# North Burnet/Gateway Regulating Plan Proposed Code Amendments

## Proposed Amendments to the North Burnet/Gateway Regulating Plan

## **Overview of Amendments:**

## Section 4.8.2 – Sign Regulations

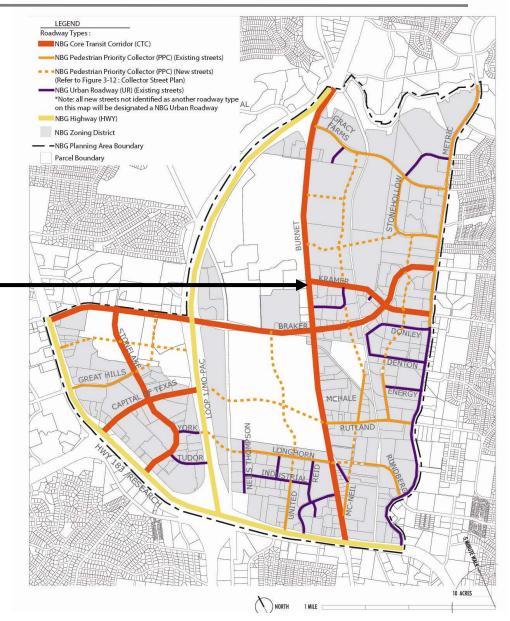
The NBG Regulating Plan currently references UNO (University Neighborhood Overlay) for sign standards.

The UNO Standards do not consider Core Transit Corridors within their regulations.

The UNO Sign Standards do not allow for appropriate signage on roads such as <u>Burnet</u>, <u>Kramer</u>, and <u>Braker</u>, which have high speeds, wide ROW widths, and wide utility easements between the ROW and property lines.

Roads designated as NBG Core Transit
Corridors (thick orange lines) will be permitted to have one freestanding
monument sign not to exceed 100
square feet in area.

Amends the NBG Regulating Plan to allow one freestanding monument sign, not to exceed 100 square feet, per property on roadways designated as NBG Core Transit Corridors.

## Adopting Ordinance No. 20111208-098 & LDC Section 25-2-767.02

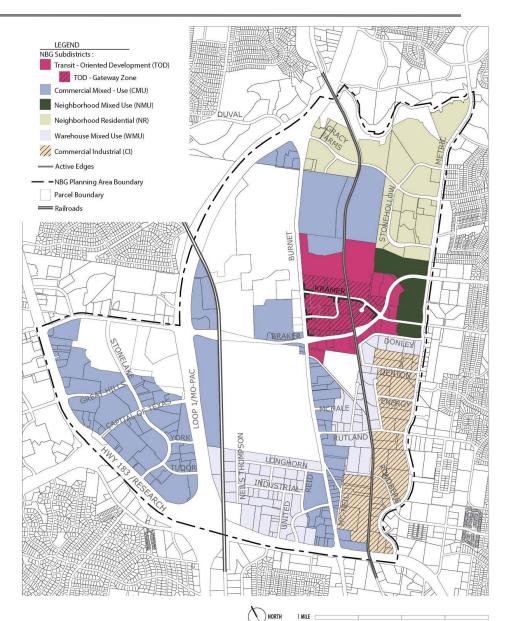
Currently, property owners can apply to change from one NBG Subdistrict to another NBG Subdistrict under a Zoning change. However, as the language in the adopting ordinance reads, updating the NBG Subdistrict Map to reflect the change in zoning requires a code amendment.

Amends the language in Ordinance No. 20111208-098 adopting the North Burnet/Gateway Zoning District and Regulating Plan to reference Figure 1 - 2: North Burnet / Gateway (NBG) Zoning District Subdistrict Map. Properties applying for a change in zoning will follow the requirements for notice of rezoning under Section 25-2-261 (Notice of Application Filing).

All other amendments to the Regulating Plan not covered under Alternative Equivalent Compliance are subject to the procedures prescribed in Section 25-1-502 (*Amendment: Review*).

## Two-Story Minimum Context

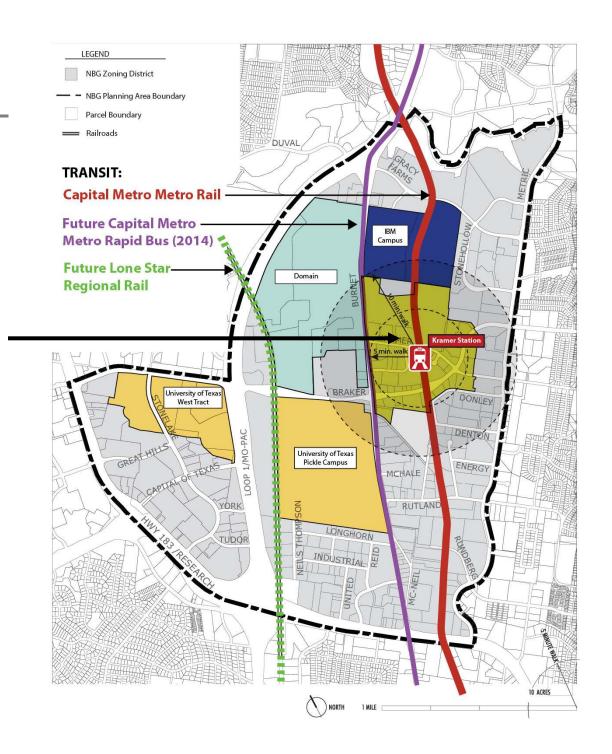
The North Burnet/Gateway Regulating Plan currently has a Two-Story minimum requirement for properties located roughly 5 minutes from the Kramer Station located along the Capital Metro Rail line.

The current language does not address double height spaces, such as atriums and mezzanines, that are often an important program and design element for large developments.

Extent of properties with a Two-Story minimum requirement

Amends the language in Section 4.2 of the North Burnet/Gateway Regulating Plan to provide clear direction on the design and limitation of double height spaces within developments with a Two-Story minimum requirement.

## Section 4.2 – General Site Development Standards (Two-Story Minimum)

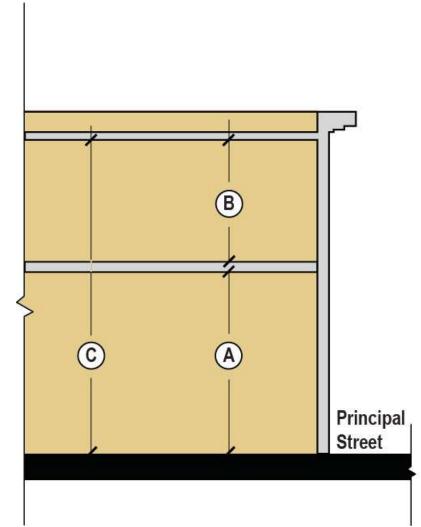
Definition	Height without Active Edge	Height with Active Edge
Α	Ground Floor: Measured from the finished floor to the bottom of structure.	9' Minimum	12' Minimum
В	Upper Floors: Measured from the finished floor to the bottom of structure.	8' Minimum	8' Minimum
С	Double Height Space, if provided: Measured from the finished floor to the bottom of floor or roof structure above.  The maximum depth of a double height space along a Principal Street is 24'.	18' Minimum Height	22' Minimum Height

Active Edge Designations are illustrated on Figure 1-2: North Burnet/Gateway (NBG) Zoning District Subdistrict Map.
